UN#10-122

**Response to NRC RAI No. 101  
Questions 02.04.12-9, 02.04.12-10 and 02.04.12-11,**

**Calvert Cliffs Nuclear Power Plant Unit 3**

**Update of COLA Part 2, FSAR  
to incorporate the new Groundwater Model**

Figure 2.4-97—{Modeled Post-Construction Depth to the Surficial Aquifer Water Table in the Unit 3 Power Block Area}

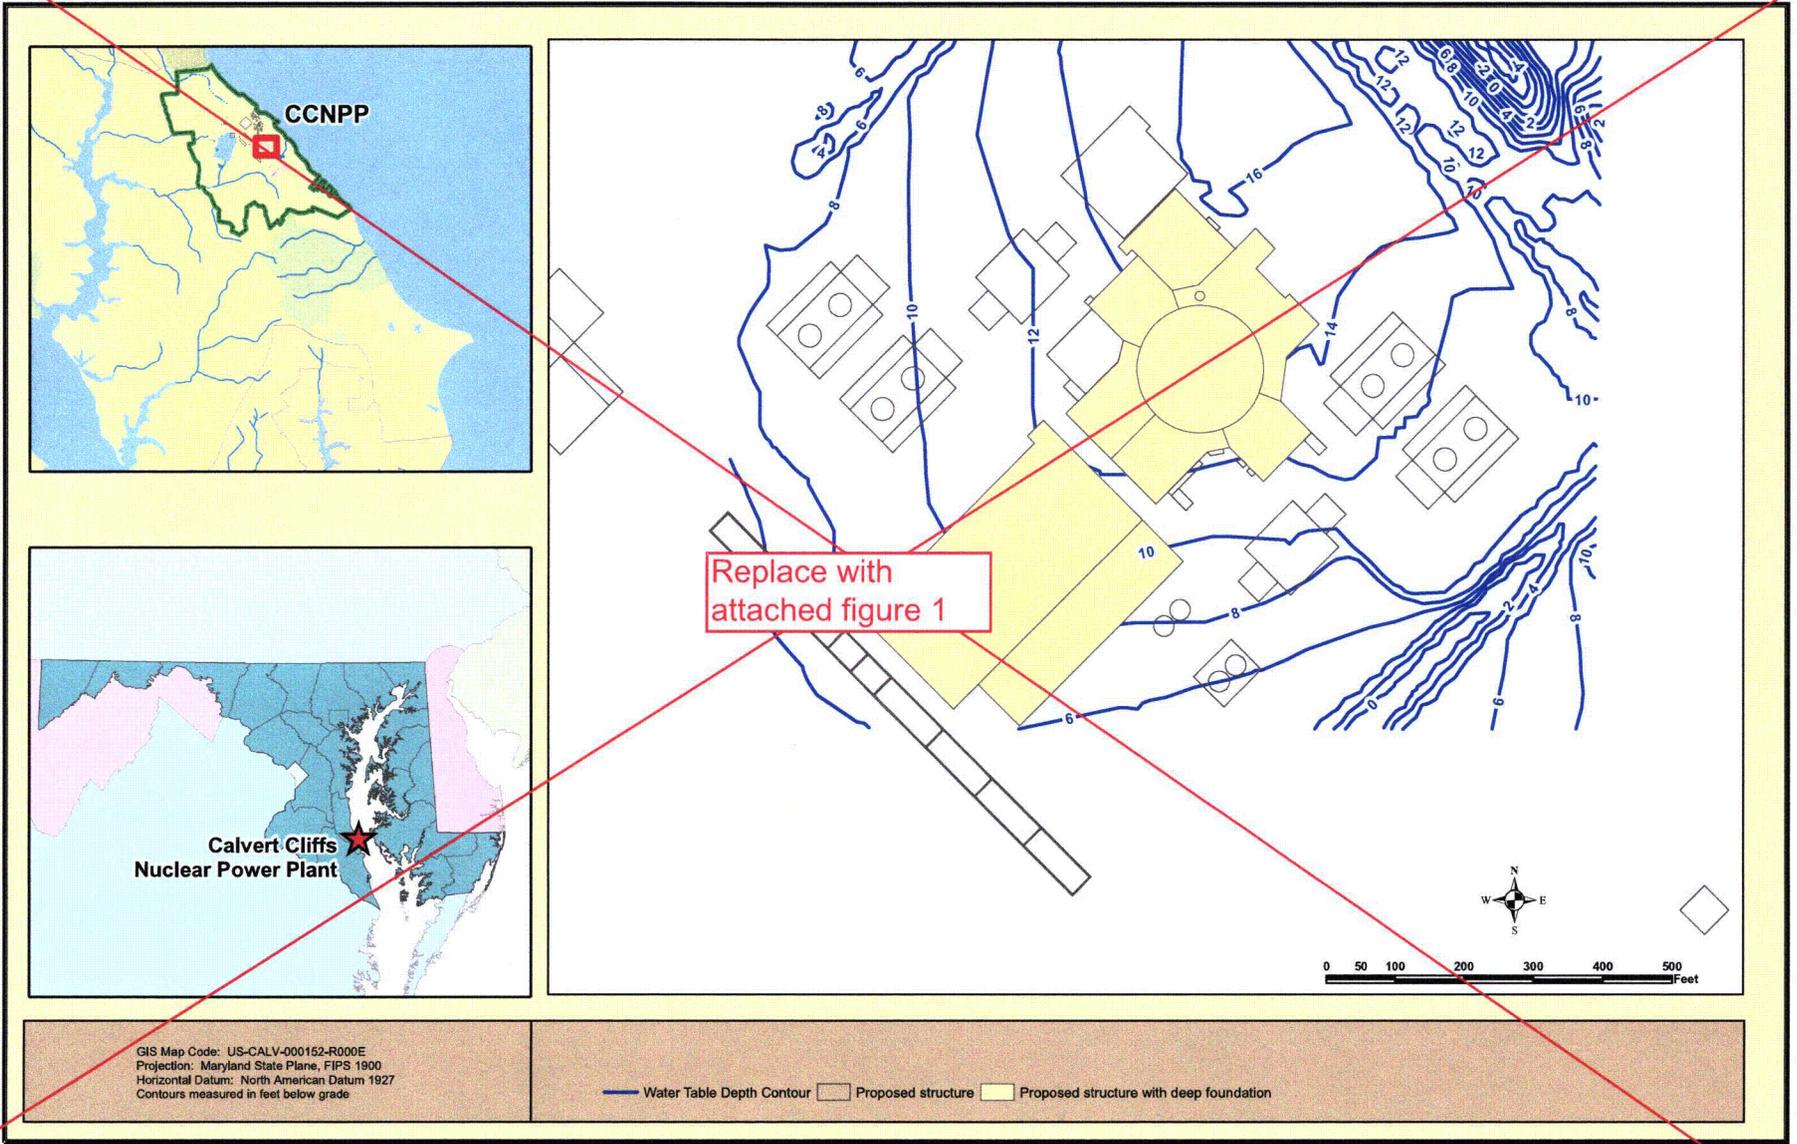
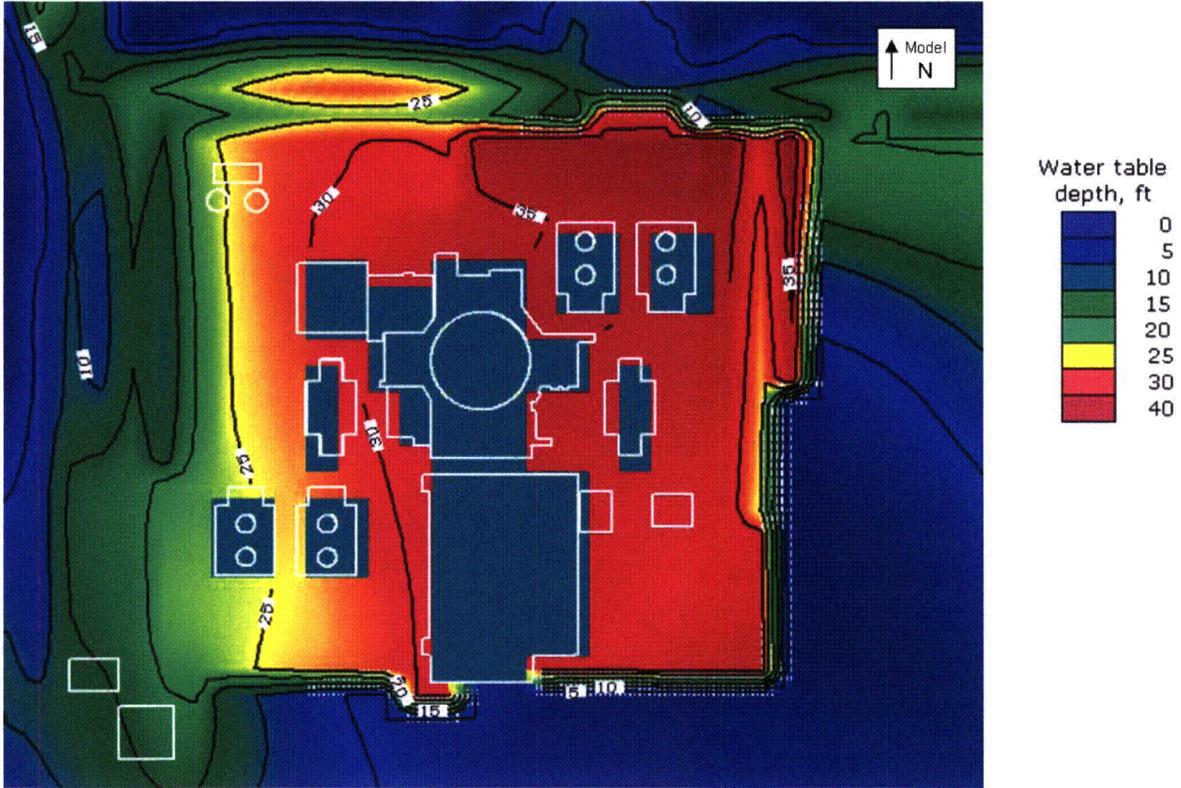
The DCD requirement on subsurface hydrostatic loading states that the maximum groundwater level is 1.0 m below grade. The results of the groundwater modeling described in FSAR Section 2.4.12.5 and Calculation No. 25237-103-KOC-HMMG-00001, Groundwater Flow Model of Surficial Aquifer, show that the DCD requirement is not satisfied at several locations and that the predicted groundwater level is very close to the DCD requirement (within one meter) over a relatively large area. Provide a discussion of the degree of conservatism of the model results and the reliability of meeting the DCD requirement on maximum groundwater level considering the following issues:

Clarify the locations of and other names for the buildings identified in Calculation No. 25237-103-KOC-HMMG-00001, Groundwater Flow Model of Surficial Aquifer, as having a depth to groundwater of less than 1.0 m: buildings 1UQB, 1URB, 1UBP, and 2UBP. A figure was provided as Attachment 3 to the Calculation that was indicated to identify these buildings. However, only 1URB could be identified on this figure, the easternmost building in the nuclear island.

The post-construction model was used to estimate piezometric levels in the powerblock area. Modeled post-construction depth to the water table in the powerblock area is shown on Figure 2.4-97. The

Replacement FSAR Figure 2.4-97

Figure 2.4-107—{Topography of the Post-Construction Groundwater Flow Model Domain}

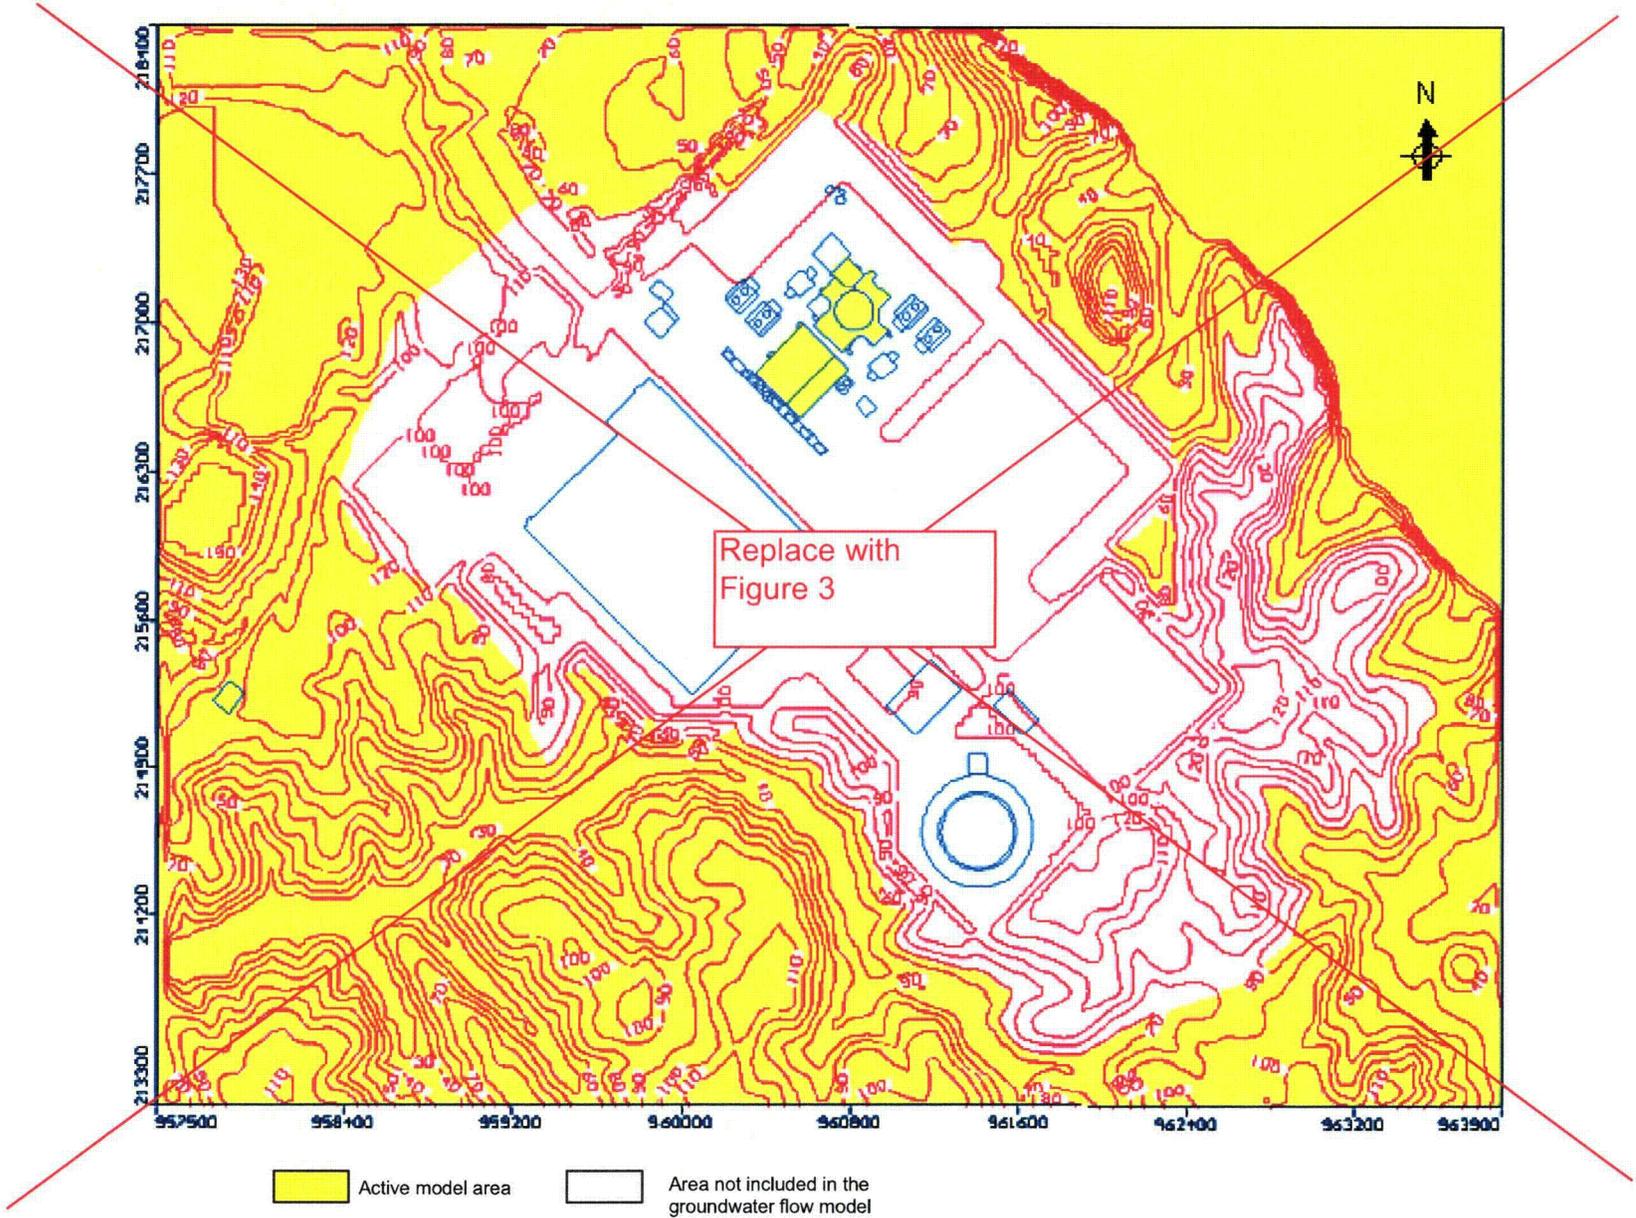
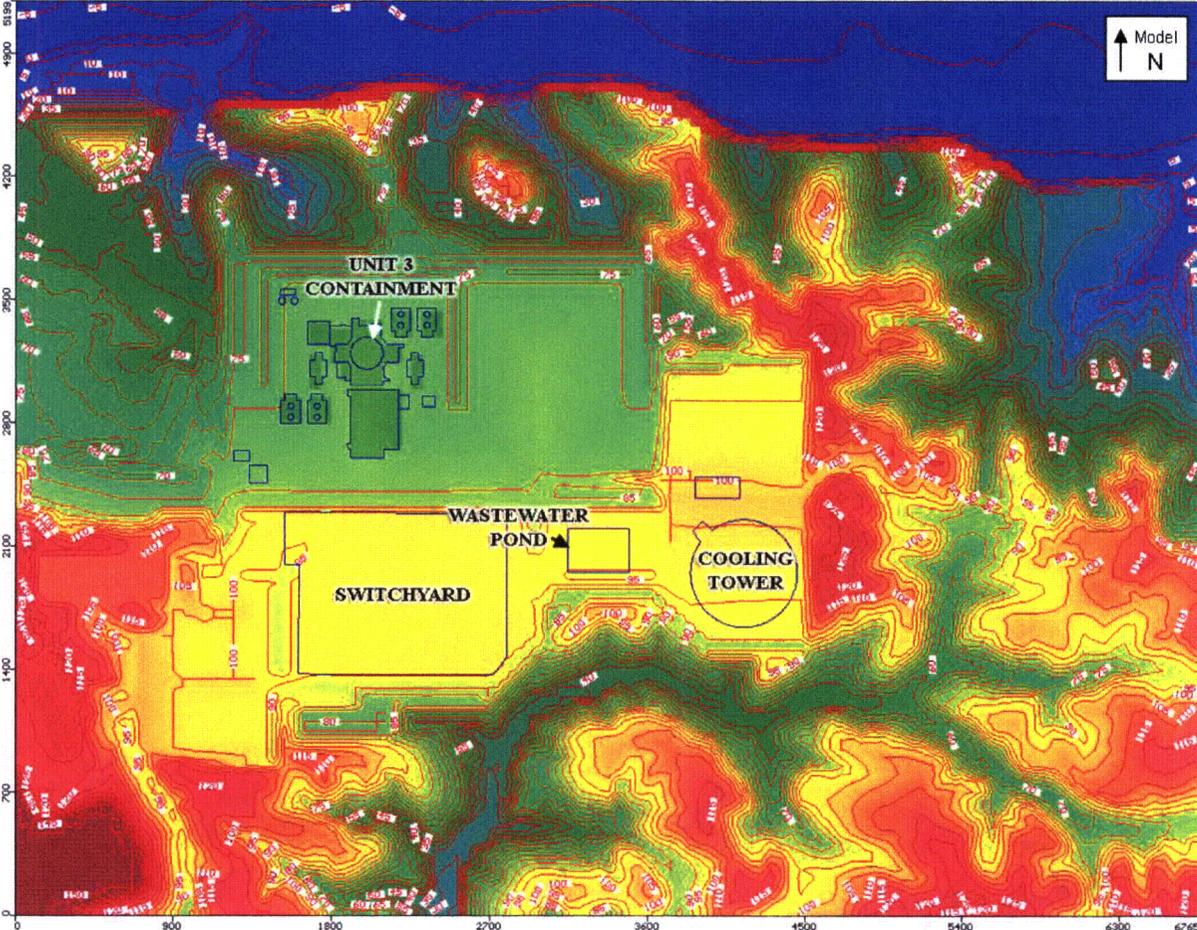
Other model errors, such as not accounting for the presence of building foundations and the surface of cut areas prior to filling;

adjacent to the Unit 3 site. Figure 2.5-129 shows the grading plan for the Unit 3 site and Figure 2.4-107 shows the post construction topography of the model domain. Both stream flow and ground water levels after construction of Unit 3 are dependent upon several factors, including the hydraulic conductivity of the engineered fill material used and the rate of ground water recharge within the graded area of the site.

Figure 3  
Replacement Figure 2.4-107
